SHDC
Planning & Development

PROJECT
Proposed Residential Development, at ~~Manor Road~~, Holbeach St. Marks, Lincolnshire, For ~~Nashmore~~ Homes

TITLE
Proposed Site Plan

Job Title
**Residential Development
off St Marks Road
Wolbeach St Marks
Hunting
Lincs**

TITLE
Proposed Site Plan

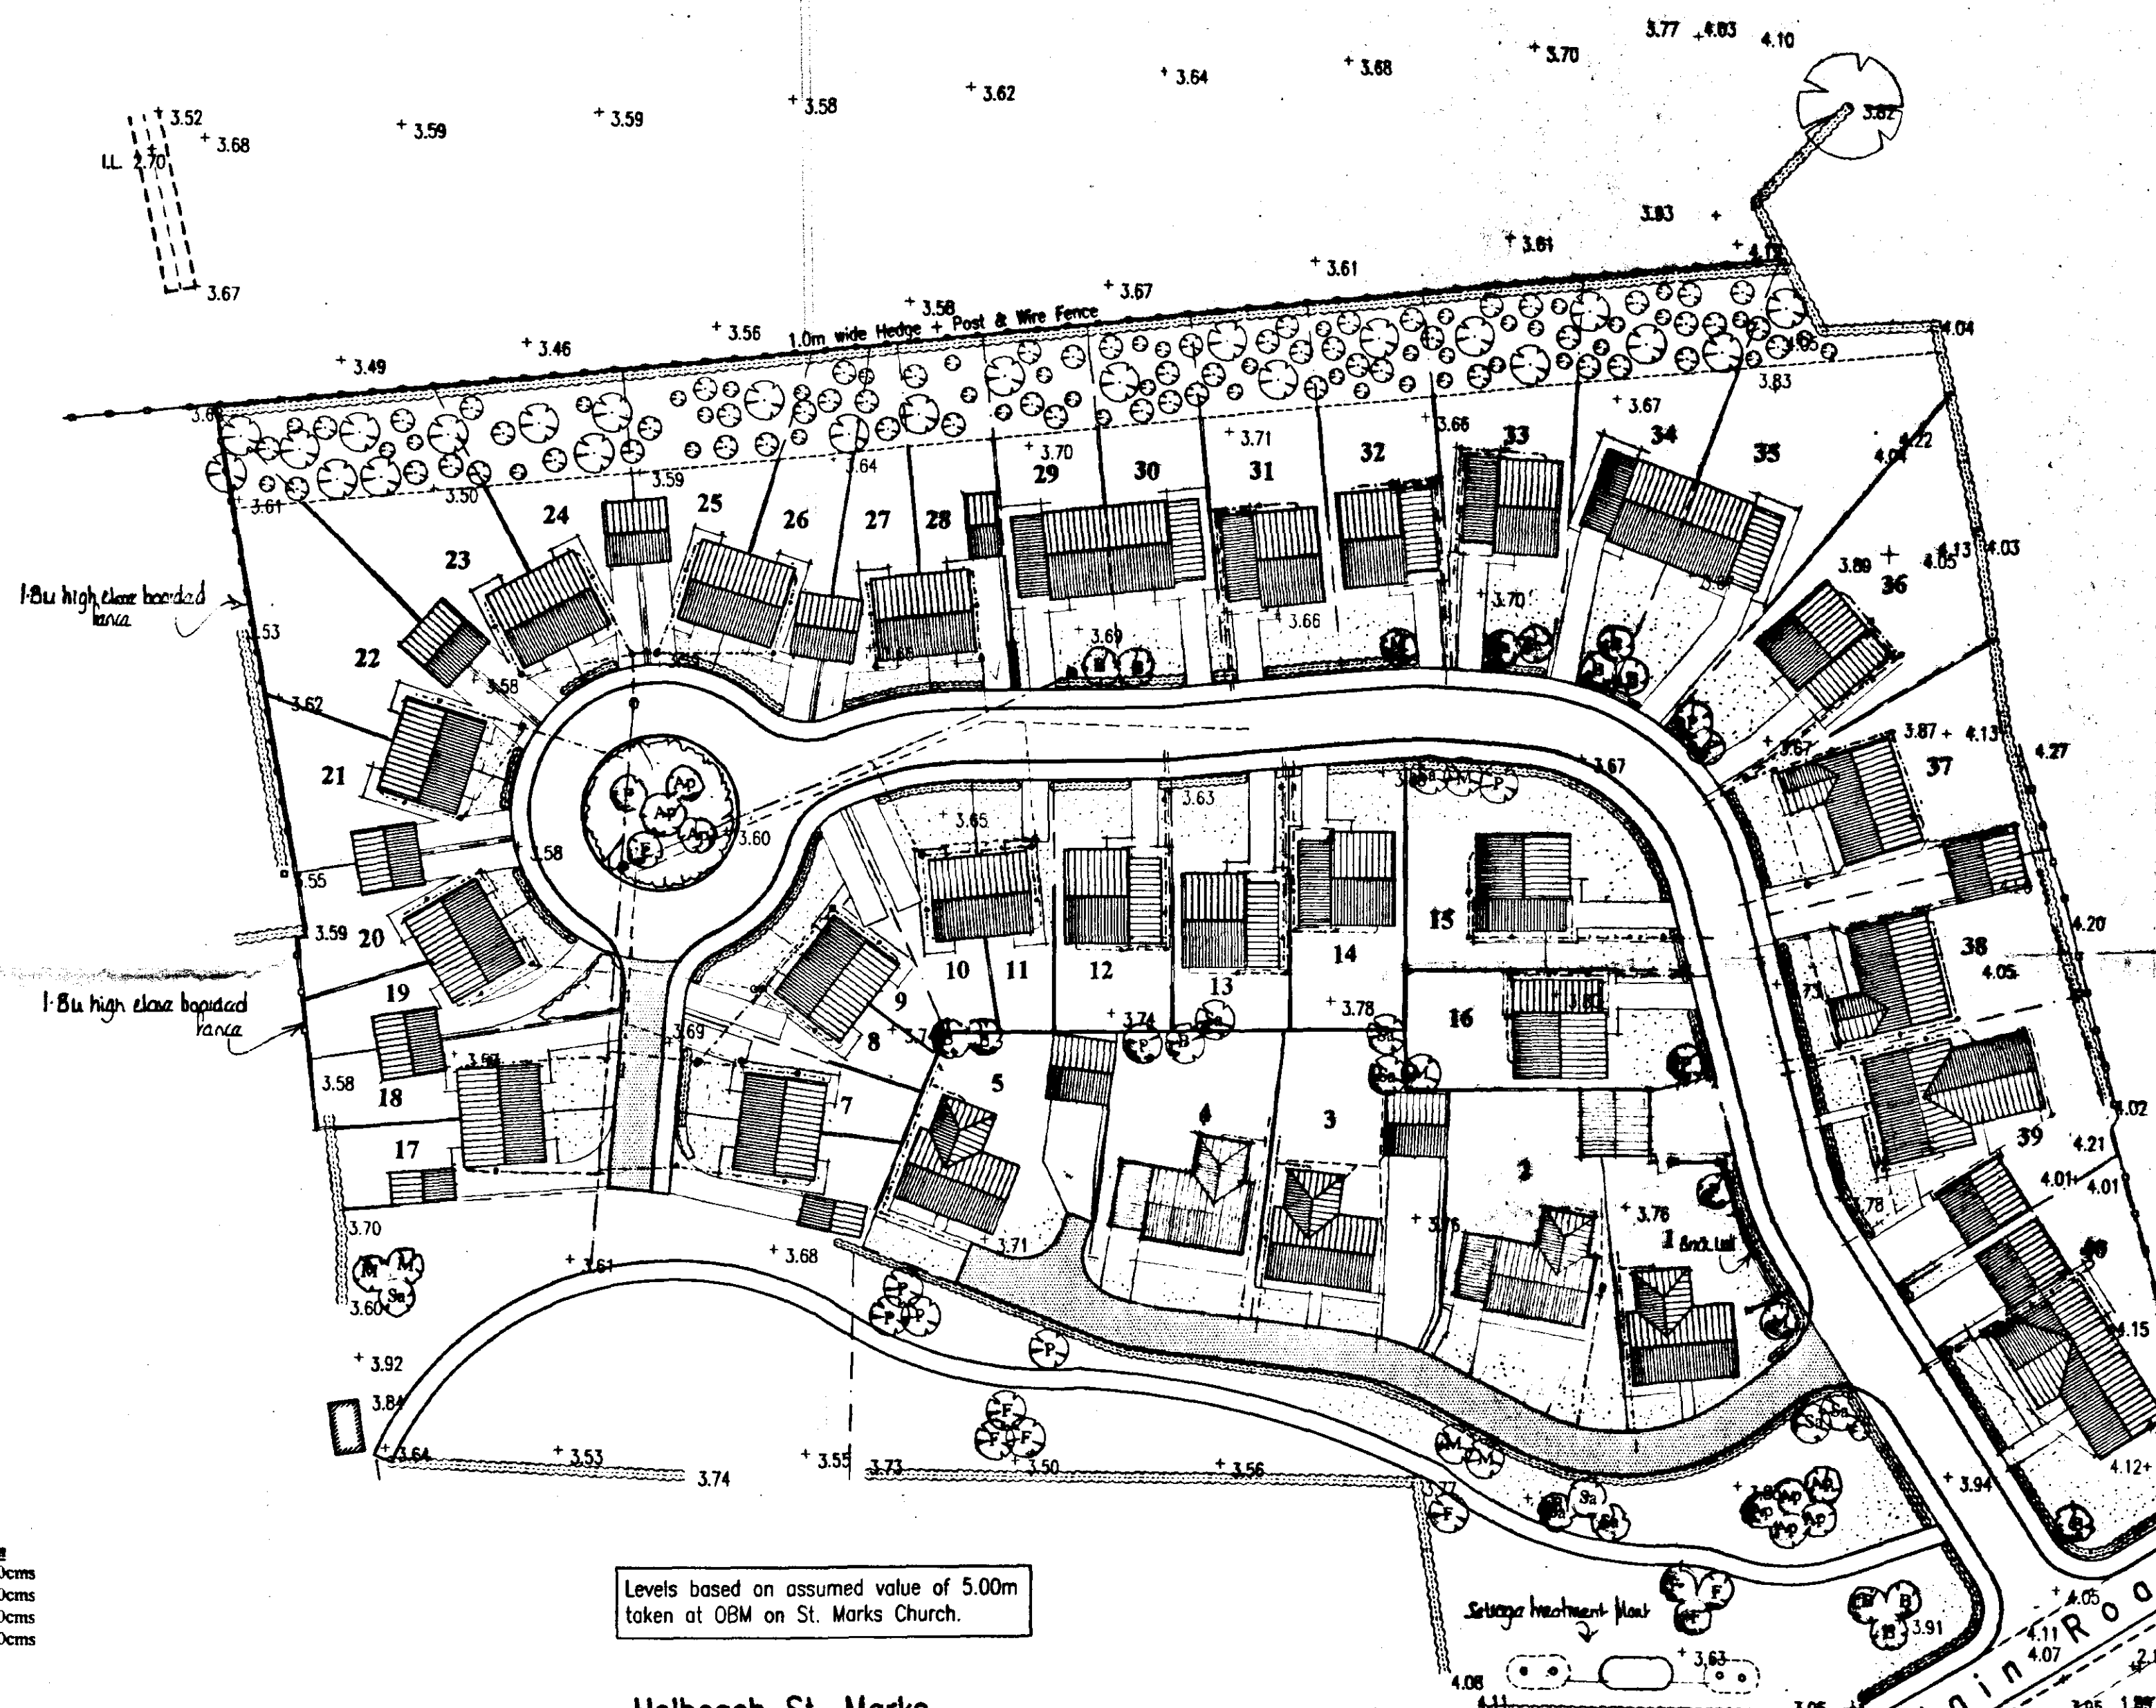
REV	DATE	REMARKS
4	14/05/02	Minor amendments to plot 2 & 4 extended
3	17/05/02	Minor amendments to plot 2 & 4 extended
2	17/05/02	Drawing revised to clients' comments.
1	16/05/02	Drawing revised to clients' comments.
0	09/05/02	Drawing revised to clients' comments.
0	18/02/02	Drawing revised to comments dated 18/2/02.
0	15/02/02	Drawing revised to comments dated 14/2/02.
0	13/02/02	Drawing revised to comments made at meeting dated 11/2/02.
